SIB 32 04 20

GROANING NOISE DURING HEIGHT ADJUSTMENT OF THE ELECTRIC STEERING COLUMN

This Service Information Bulletin (Revision 1) replaces SI B32 04 20 **dated September 2020**.

Adjustment to the spindle drive

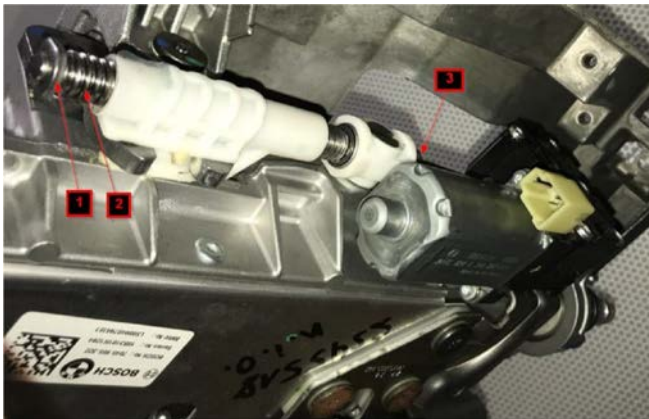
A groaning type noise is heard during the height adjustment. See attached video V32 01 20

Spindle drive of the electric steering column height adjustment

The spindle drive (2) is located on the right side of the steering column as viewed from the driver's seat

The stop panel (1) of the spindle drive will need to be turned 90 degrees clockwise.

Before adjusting the stop spindle, the lock nut in the rear of the drive (3) must be secured in place

3. Using a 13mm crows' foot on the end of a long extension, secure the lock nut at the back of the spindle.

4. With the rear lock nut secured, rotate the stop panel 90 degrees clockwise using a 13mm open end wrench. See attached video V32 02 20.
